To: T10 Committee (SCSI)

From: George Penokie (IBM/Tivoli)

Subject: SAS 1.1 - Transport layer retry and argument passing fixes

Figure 149 — ST\_I (transport layer for SSP initiator ports) state machines

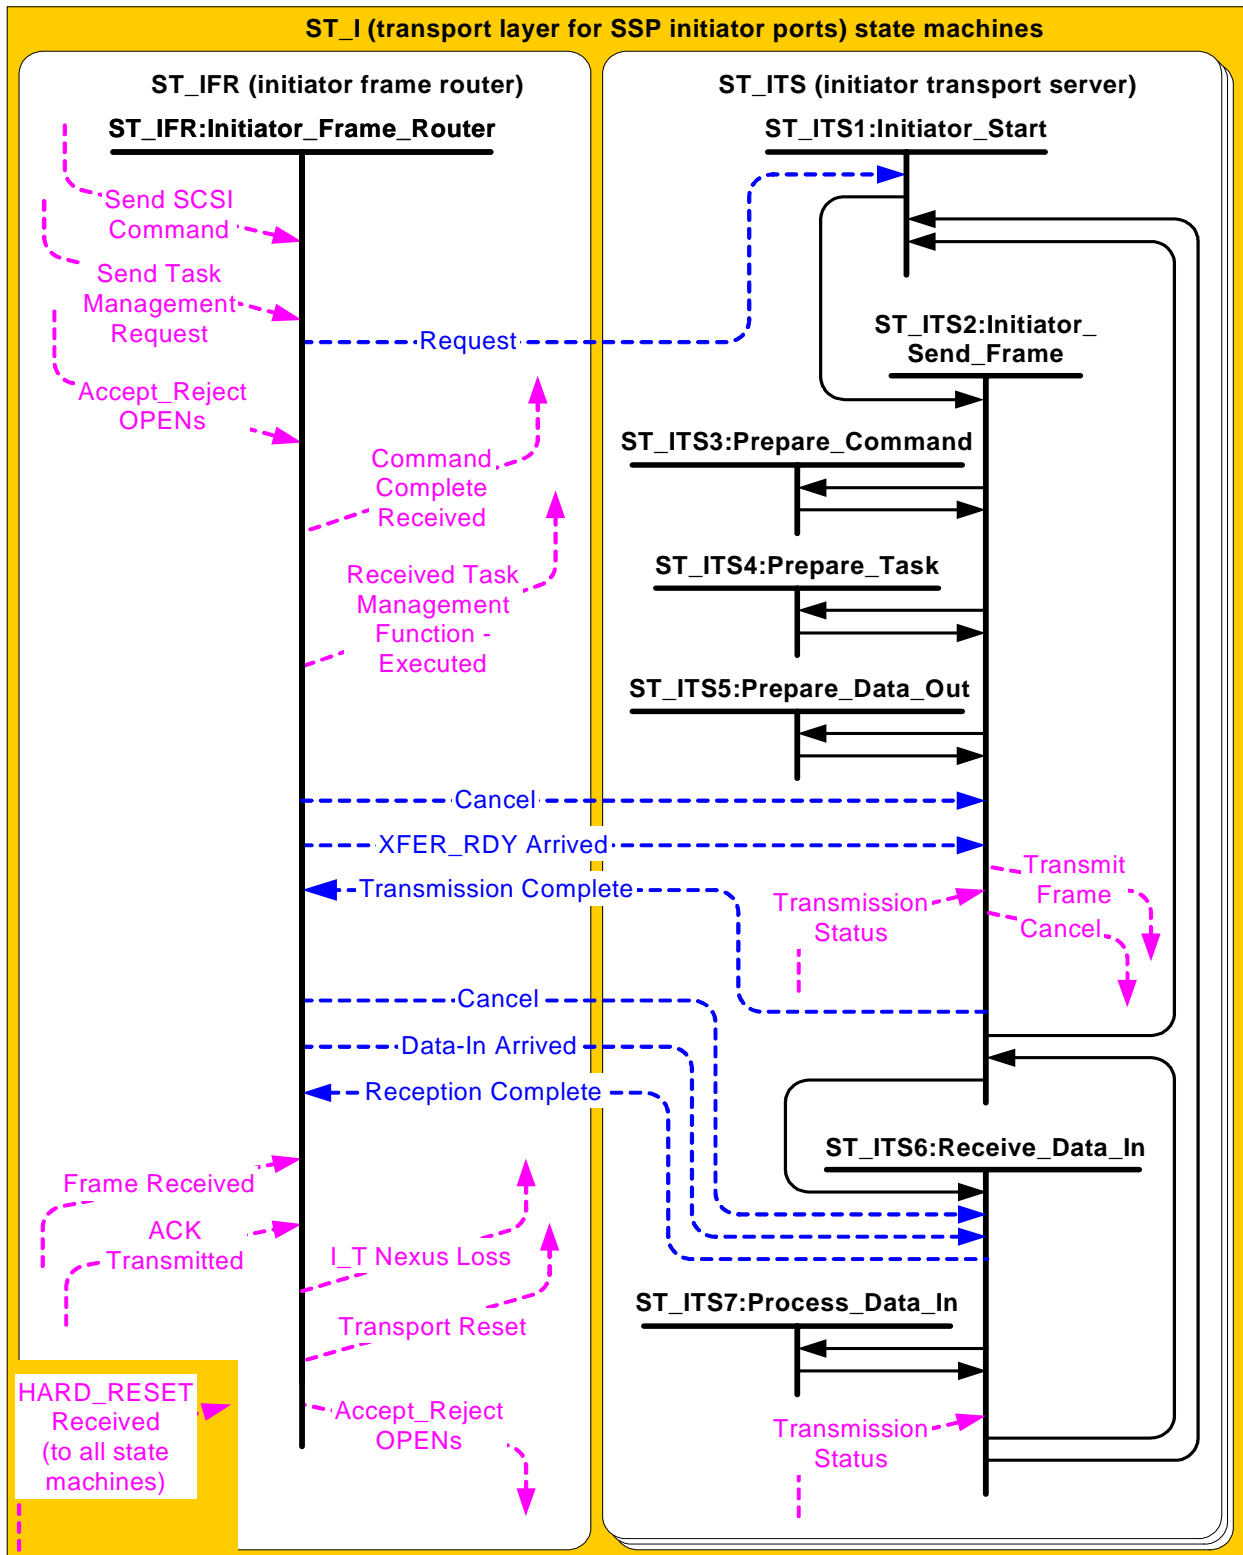
During letter ballot review of SAS 1.1 transport layer state machine descriptions it became apparent that the frame level retry description in the state machines was not complete and that the states in state machines that contained more than one state were not passing arguments. There appeared to be an assumption that a state would always have the information it wanted without regard as to where the information came from.

This proposal addressed both those problems. All changes are indicated with blue underlines and red strike-through.
